RE: Request for more information
Application No: DA2022/2207

Proposal: **Demolition works and construction
of a dwelling house including swimming pool**

Property: 30 Abernethy Street SEAFORTH

Figure 1.

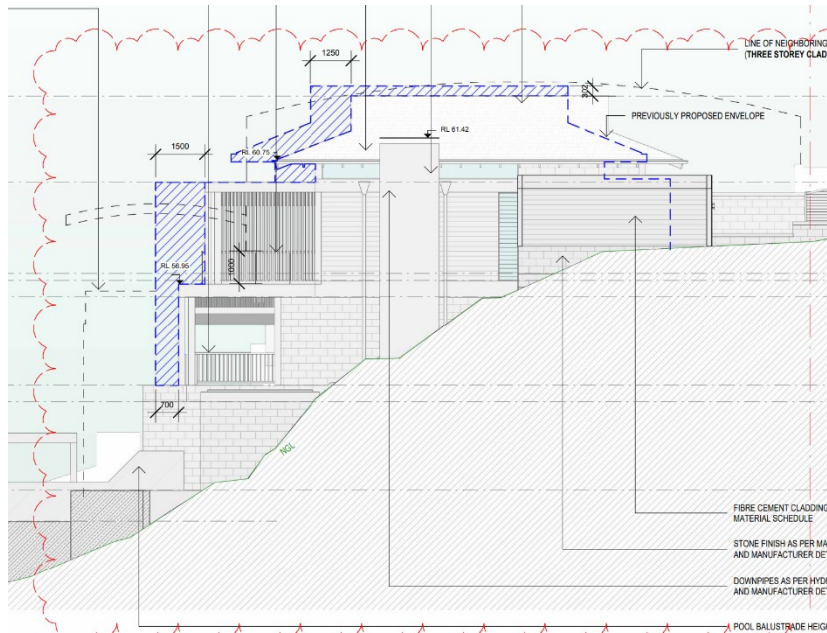
a) The western portion of the pitched roof form exceeds the 8.5m LEP building height and will result in an increased view impacts for the sites to the east, when compared to a compliant design. Whilst it is appreciated the roof form is part of the architectural style of the building, this element is non-compliant with the height control and results in additional view impacts upon water views. There is scope to reduce the height of this roof to mitigate view impacts.

b) The pergola, balustrading and supporting columns of the first-floor deck exceed the LEP height limit and the DCP wall height. The first-floor deck and pergola results in direct view impacts of the city skyline from the living spaces of 36 Abernethy. Whilst this view is across a side boundary, the impact is due to a non-compliant element and the view is considered to be of high value. A design which complied with the height plane would stepped back with the topography of the site and likely retain this view corridor.

The non-compliance with building height results in direct view impacts. The upper-level design and roof form does not follow the topography of the land and as such, results in an exceedance of the height limit and does not minimise bulk and scale. Whilst it is acknowledged that strict compliance with the building height is difficult to achieve on such a sloping site, the top floor is not adequately stepped back with the topography of the land to follow the height plane to retain view corridors and mitigate building height and scale.

Response – As per the council's request, we have substantially lowered the roof height and decreased the roof pitch to accommodate a reduction in height by 302mm. Furthermore, we have repositioned the first floor and roof footprint by 1500mm towards the front setback, resulting in a substantial reduction in non-compliance. The balcony's depth has also been reduced by 700mm in accordance with the council's stipulations. For a visual depiction of the enhanced outcome, please refer to Figure 1 and 2. Please refer to Clause 4.6 variation request - Height of buildings prepared by BBF town planners. We are of the opinion that these modifications should be deemed suitable, considering the current site grade, and have markedly improved the height plane non-compliance.

Figure 3.

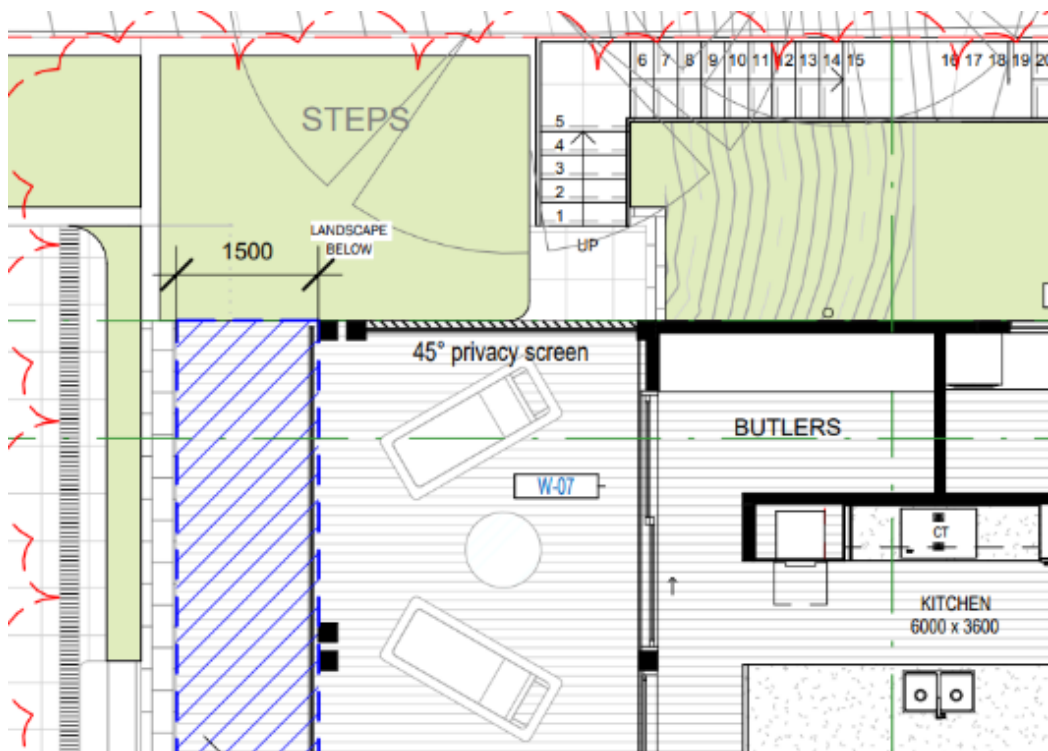
The top floor balcony does not result in a reasonable level of privacy for the adjoining two properties, with overlooking over the side boundaries of concern. It is noted this element is in breach of the height and as such, the resulting privacy impacts are considered unreasonable. If privacy screening along the side elevations were to be introduced, this may increase view impacts and increase the apparent bulk of the building. Whilst upper-level balconies could be supported given the site topography, privacy needs to be further resolved through the balcony design for Council to support an elevated balcony.

Response – A vertical privacy screen set at a 45-degree angle has been incorporated to address privacy concerns. Refer to Figure 3

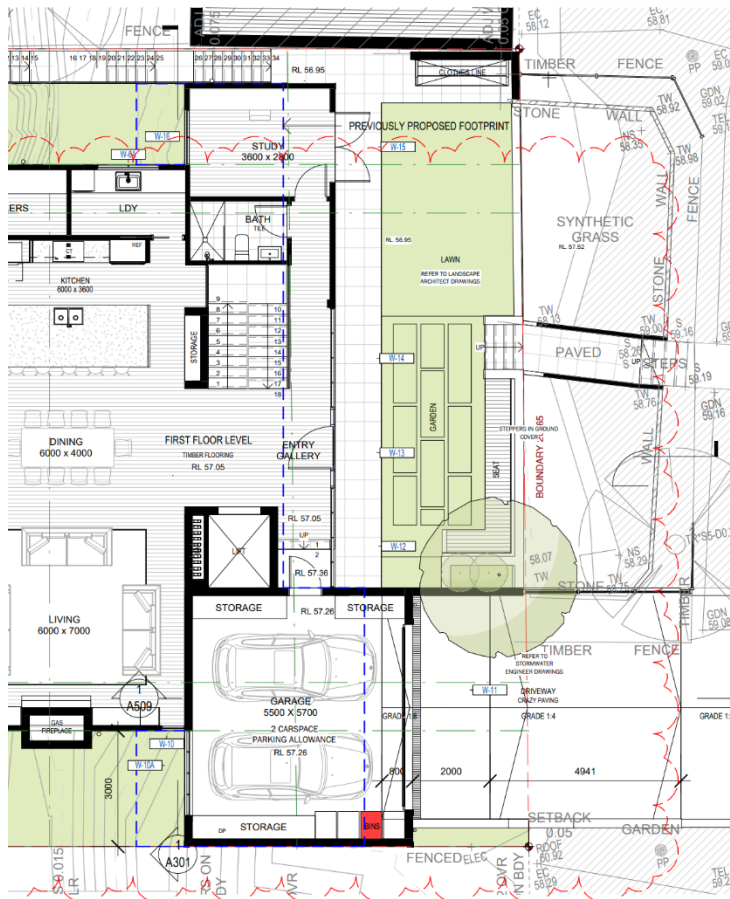
Could you please update the view from sun diagrams to include the solar panels, northern courtyard and north facing windows of No.26 Abernathy so Council can accurately determine the solar outcomes for the adjoining property.

Response – All shadow diagrams have been amended to reflect the neighbor's (No. 26) solar panels, northern courtyard, and north-facing windows, as requested by the council.
